ROCKWALL COUNTY
RFP FOR CONSTRUCTION FOR CRENSHAW ROAD
EAST PROJECT
ADDENDUM NO. 03

A | 24' CONCRETE PAVEMENT (PERMANENT) TYPICAL SECTION

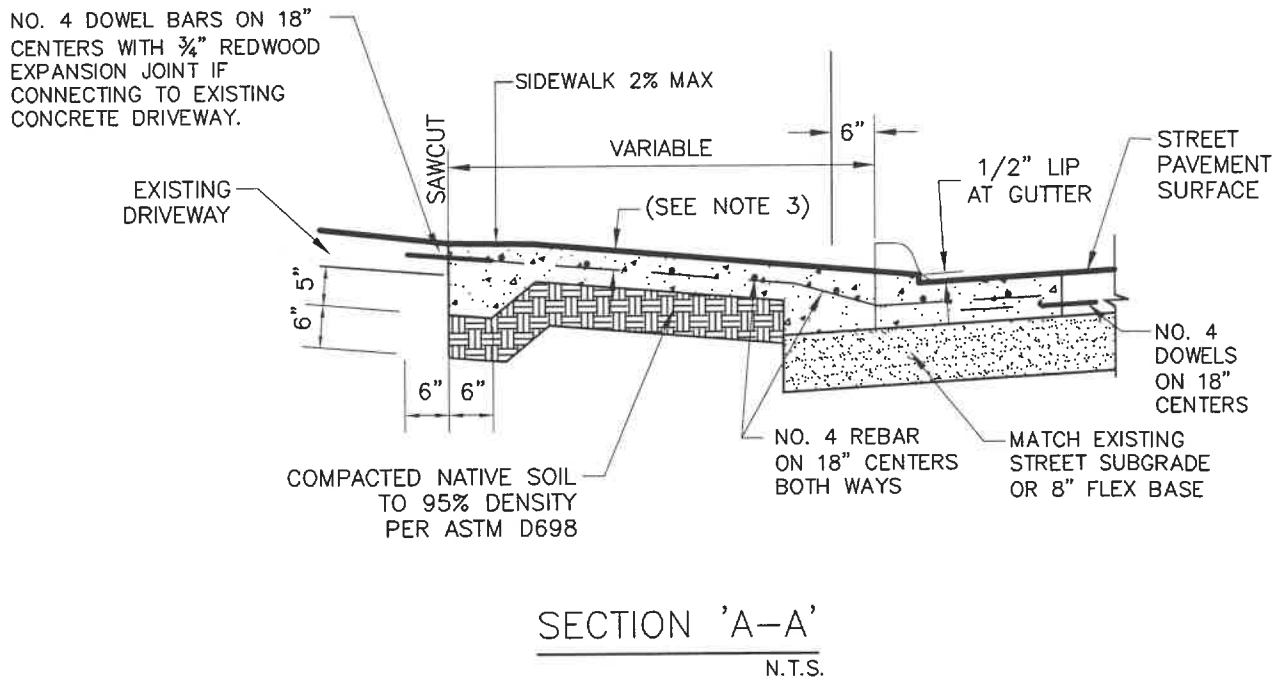
Q2. Plan sheet C-13 has a callout for CONST. PROP. CONCRETE DRIVEWAY that references SECTION A, SHEET C-10. Sheet C-10 has two typical sections for Crenshaw Road and a detail for asphalt transitions, but no detail entitled SECTION A. Please clarify and provide details for the concrete driveway.

A. Please see the detail for section A (attached).

Detail for
Section A

Addendum No. 03
Q2

RESIDENTIAL DRIVE APPROACH
ON A CONCRETE STREET

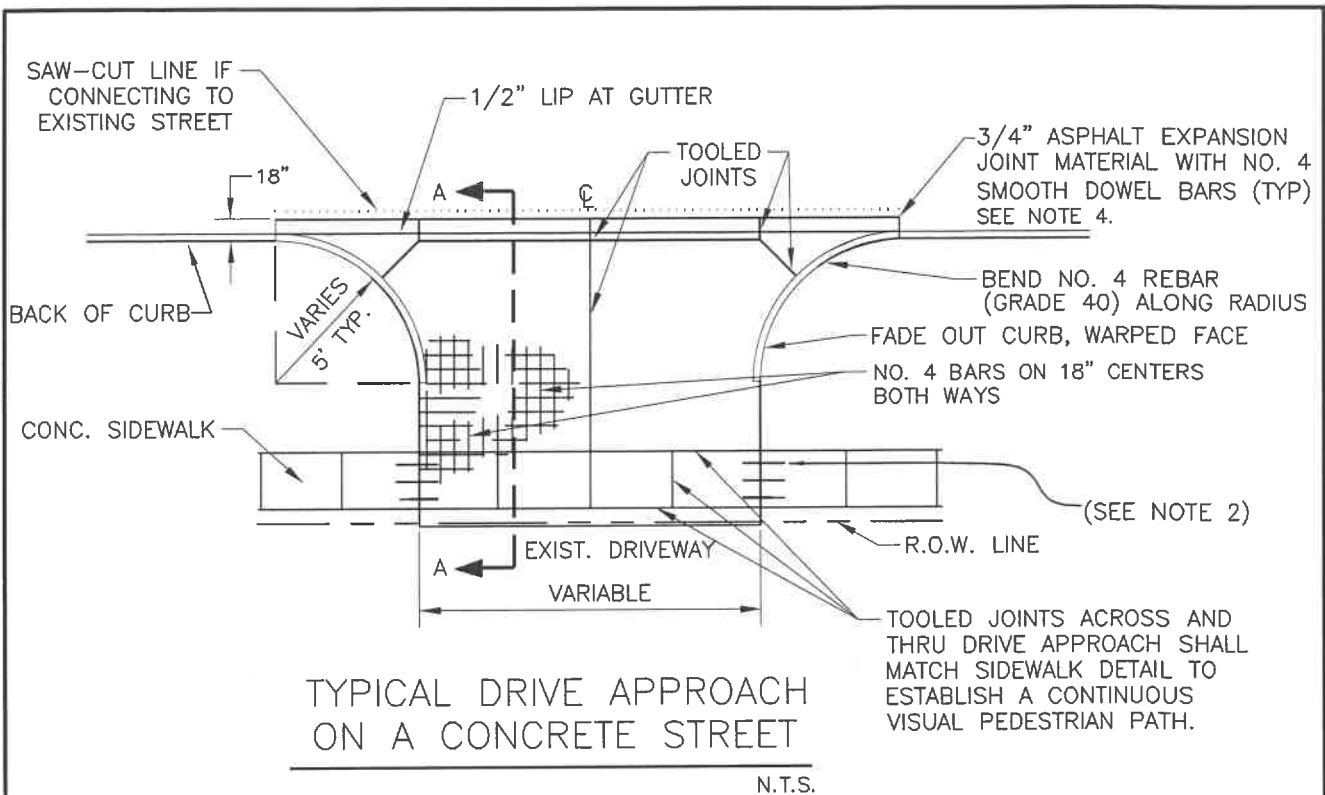
Q10. Please provide details for bid item P3 - 6" Concrete Driveway and P4 – ¾" Crushed Limestone Gravel Driveway.

A. Driveways to be constructed per attached NCTCOG detail 2150C. ¾" Crushed Limestone Gravel Driveway shall be 6" thick (attached).

NCTCOG Detail Addendum No. 03 Q10
